Charlotte Historic District Commission

Staff Review HDC 2016-324

PROPERTY ADDRESS: 1816 Wickford Place, Lot 4 (corner)

SUMMARY OF REQUEST: New Construction

FRONT ELEVATION

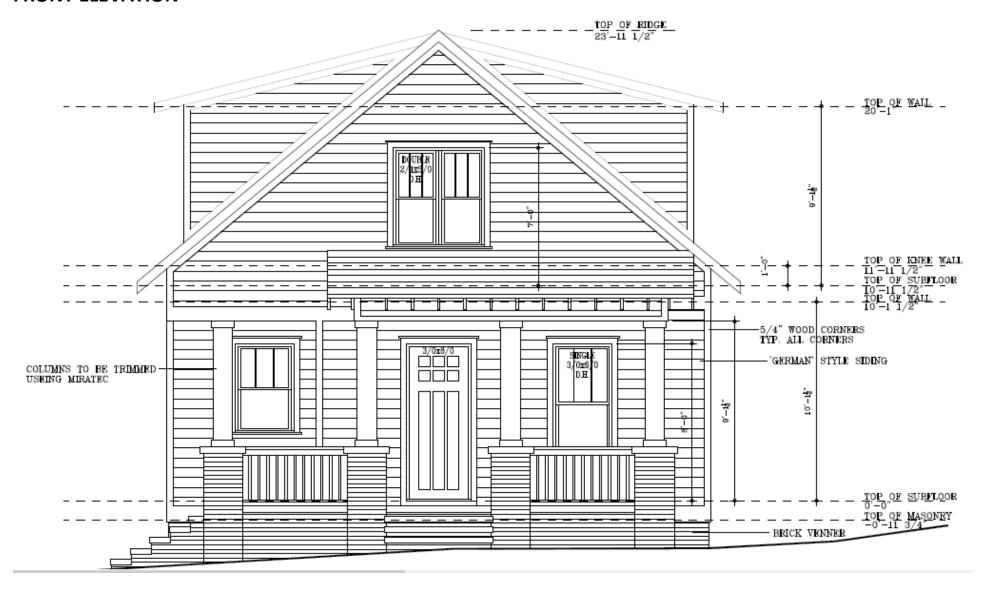
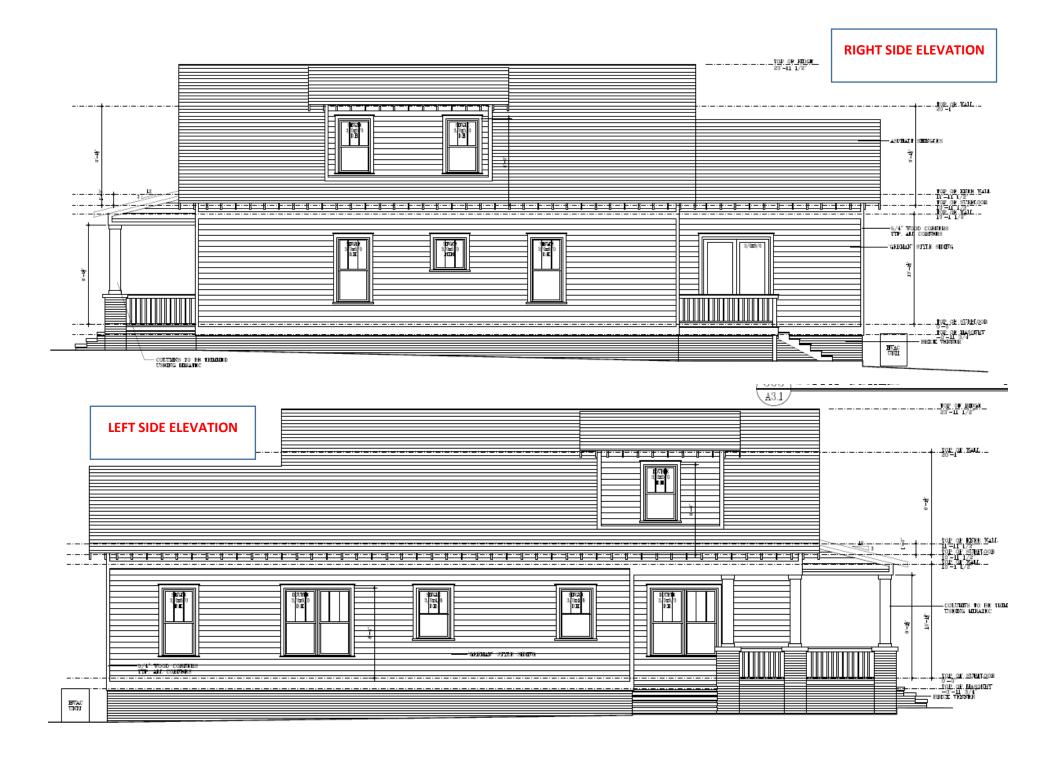
The application was continued from May for the following items: 1) Revised front and left elevations of the porch roof, 2) Add notes that the footings for the porch roof will be hand dug and a barrier around the tree shall be at least one foot between the footings and tree, 3) Provide a drawing of the footing at the perimeter of the front porch per the arborist letter.

- 1. The elevations have been revised to reflect the new porch roof design
- 2. Details of the porch footings are being updated

- **1. TREE PRESERVATION** the corner Willow Oak Tree will have a protection fence the duration of construction and the fence will be located one (1') foot from the positioning of the foundation / house.
- **2. FLOATING FOUNDATION** provided is documentation from our engineer Matthys Barker (President, Sustainable Engineering and Efficient Designs, PLLC).
- **3. UPDATED FRONT ELEVATION** the roofline of the front porch has been updated.

SOFFIT DETAIL - UPDATED OPEN TAIL

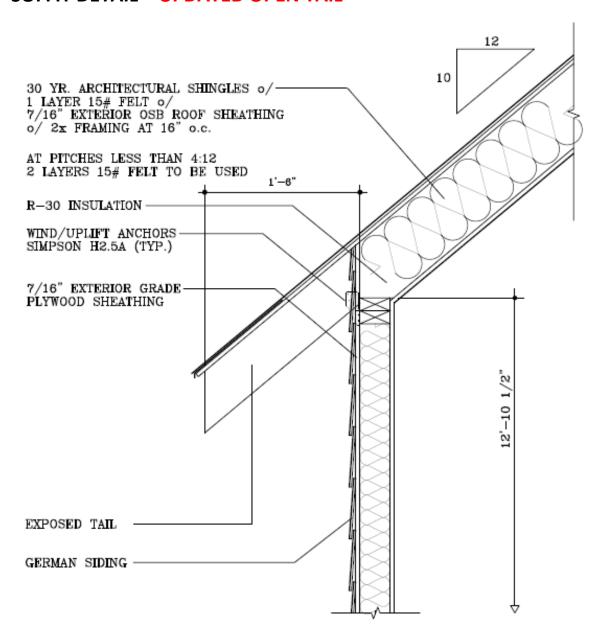
- 1. Landscaping A tree protection plan has been provided.
- 2. Materials Material notes have been updated.
- 3. Fenestration Window trim detail has been updated.
- 4. Other –Roof eave design (open rafters) and section detail have been revised.

- **1. TREE SAVE** attached is a letter from Barry Gemberling (Arborguard) in regard to his recommendations on how to keep the LOT 4 (Willow Oak) tree safe prior and during construction.
- 2. MIRATEK to be installed on all columns, corners and fascia with corner boards being 5.5 inches
- **3. OPEN TAILS / SOFFITS** roof to extend 24 inches at right angle to siding, with ¾ v-groove bead board and 2x8" rafters with bed mold installed base
- 4. WINDOWS 4" wide non-tapered trim with 7/8 putty glaze, removed brick casing
